Joint Task Force-Red Hill

Bi-Monthly Quality Validation Working Group Meeting

27 July 2023

Subject: Supplemental Information for Use in JTF Response to 23 June 2023 DOH Email
Regarding Red Hill Bulk Fuel Storage Facility (RHBFSF) Harbor Tunnel Pipe
Supports and Pipeline Corrosion

Figure 7 – DCRs for Missing Pipe Support Analysis, Harbor Tunnel

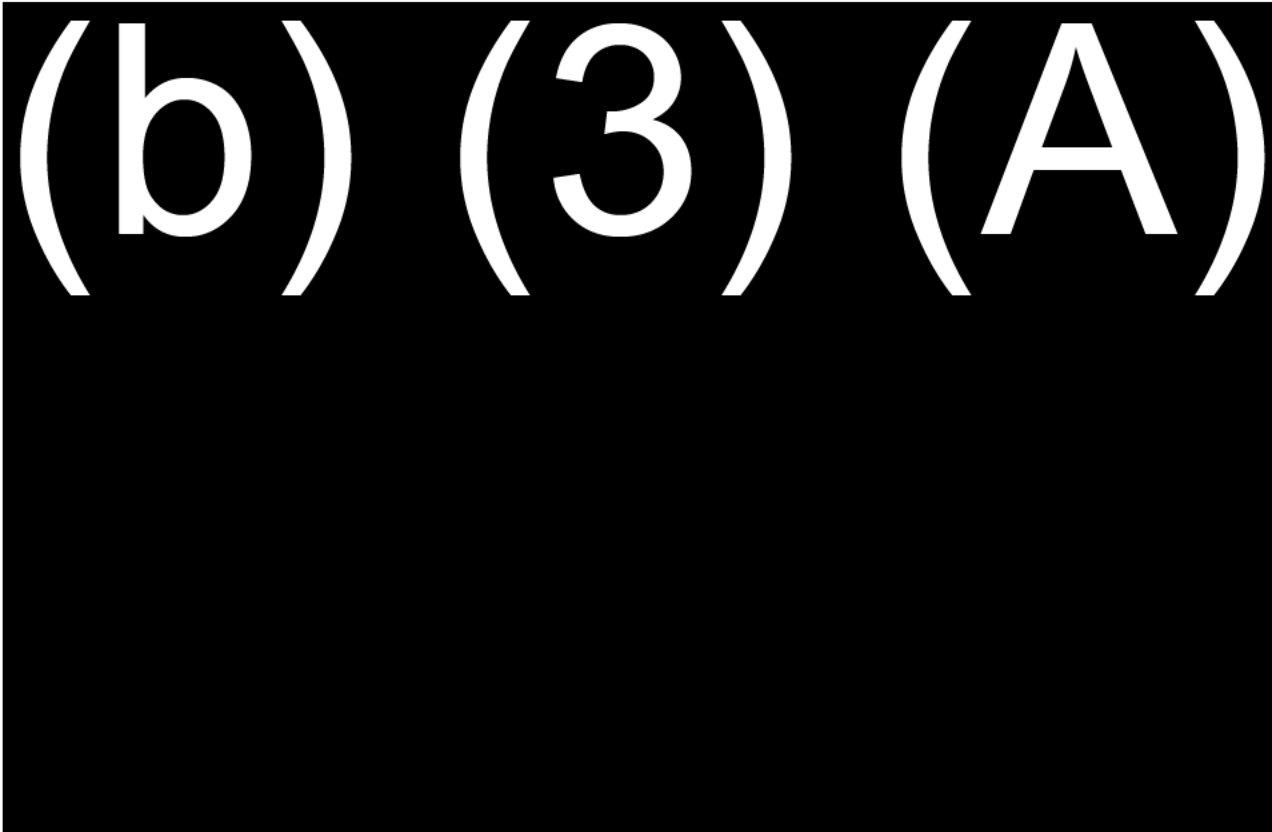
Our re-evaluation results are shown in Figure 7. Only DCR ratios above (b) (3) (A) are shown for clarity in this figure, and it shows the original analysis results with and without (b) (3) (A) included in the FE model. The maximum DCR, as shown on the right of the figure, is (b) (3) (A)

(b) (3) (A)
In other words, the re-evaluation results

demonstrate that repairs for these pipe supports are not required prior to the defueling process, and there is enough redundancy in the system to accommodate the extra loads due to the postulated loss of pipe support.
